# REGIONAL REVIEW FINDING

**Submitting Local Government:** City of Canton  
**Name of Proposal:** Riverstone

Preliminary Report:	August 24, 2006	<b>DEVELOPMENT OF REGIONAL IMPACT REVIEW REPORT</b>	Project:	Riverstone #1113
Final Report Due:	December 7, 2006		Comments Due By:	September 23, 2006

D.R.I. MASTER PLAN  
**RIVERSTONE**  
LOCATED IN THE CITY OF CANTON  
**BRIGHT - SASSER CANTON, L.L.C.**

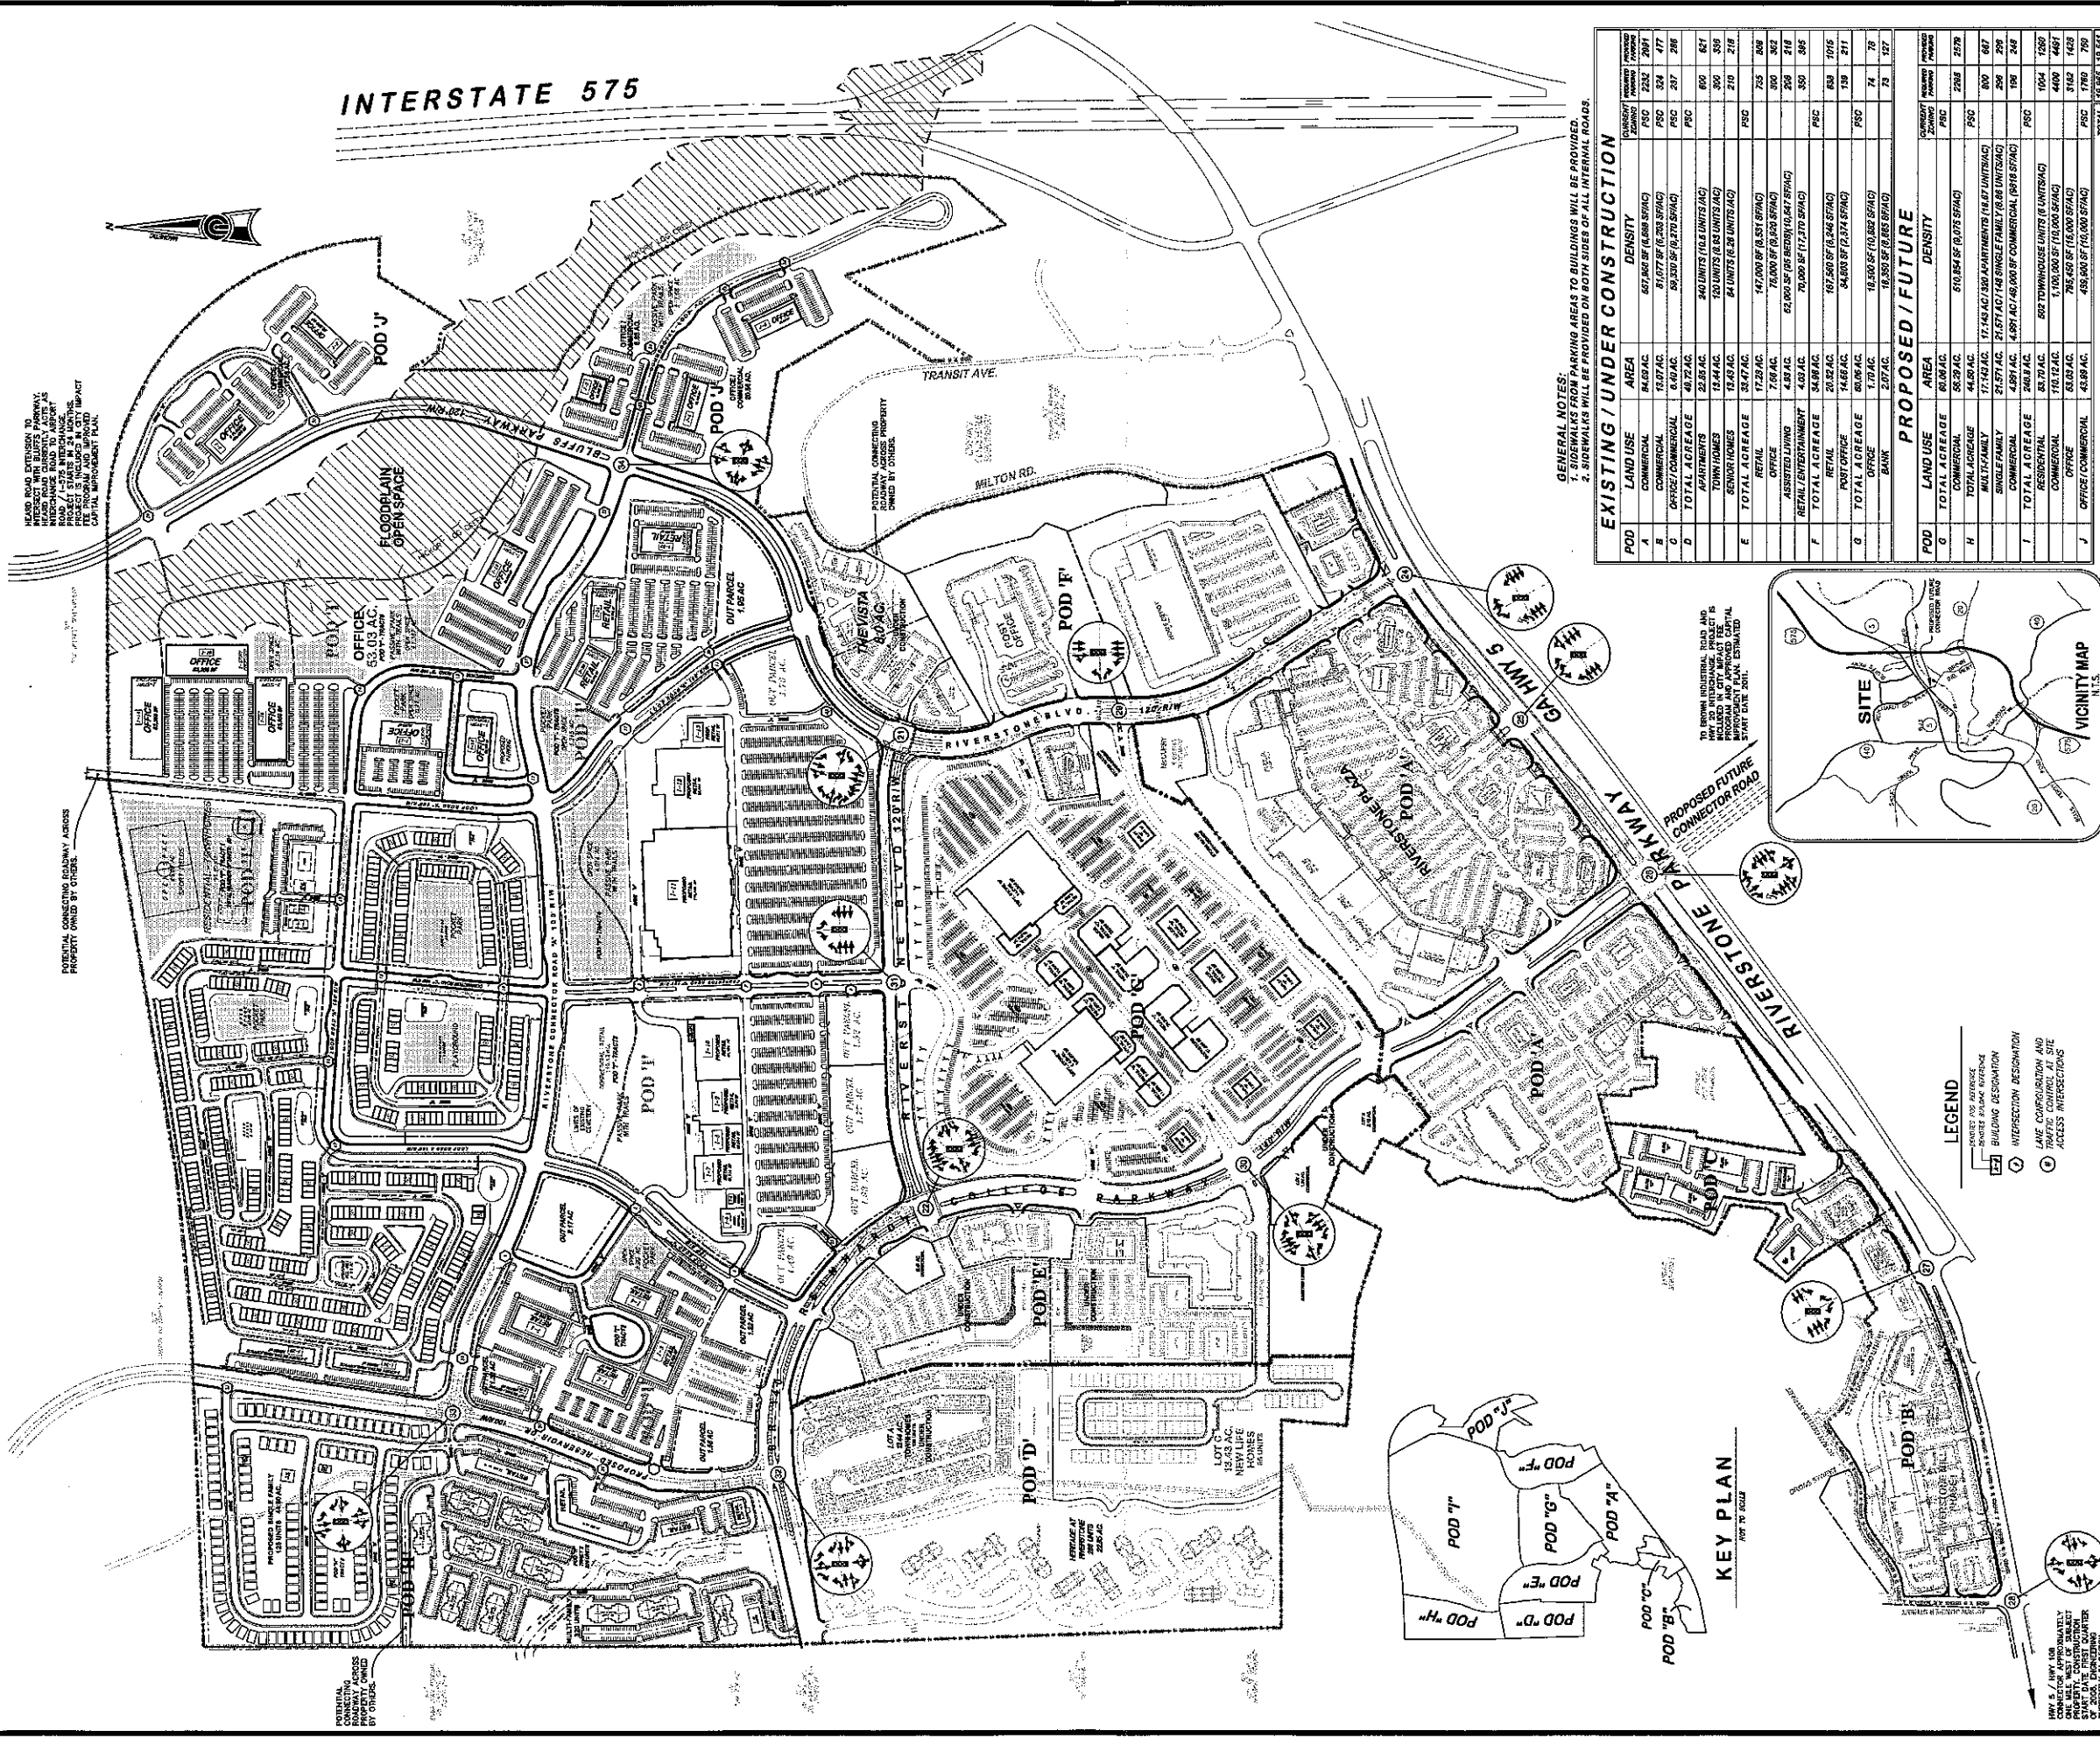
The proposed development provides multiple uses within the same site, yet fails to truly integrate those uses in a compact, vertical mix that encourages pedestrian movement and less dependence on the automobile. The commercial areas are dominated by parking lots and fail to give the community a

sense of place. Less than 25 acres on the site plan is identified for open space. Amenity centers and clubhouses are proposed for the individuals residential pods.

Staff recommendations include refining the site plan to better integrate the proposed land uses where capable. Site plan recommendations include additional inclusion of passive and active park space. A centralized amenity center should be added to the overall development to provide a place for residents of the development to gather. Consideration of a greenway throughout the development to connect the various land uses and provide safe, convenient access to the various land uses within the development is strongly recommended. Outparcels located throughout the commercial pods should not have direct access onto roads, including Riverstone Boulevard, Bluffs Parkway, Riverstone Connector Road, and Reinhardt College Parkway. Future access points along Riverstone Blvd, Bluffs Parkway, and Reinhardt College Parkway should be minimized. Shared access points and internal connectivity within the individual pods should be implemented. Reduced parking spaces should be allowed to encourage alternative modes of travel throughout the entire development. The current free shuttle provided should be expanded to include stops throughout the residential areas, as well as the office and commercial areas.
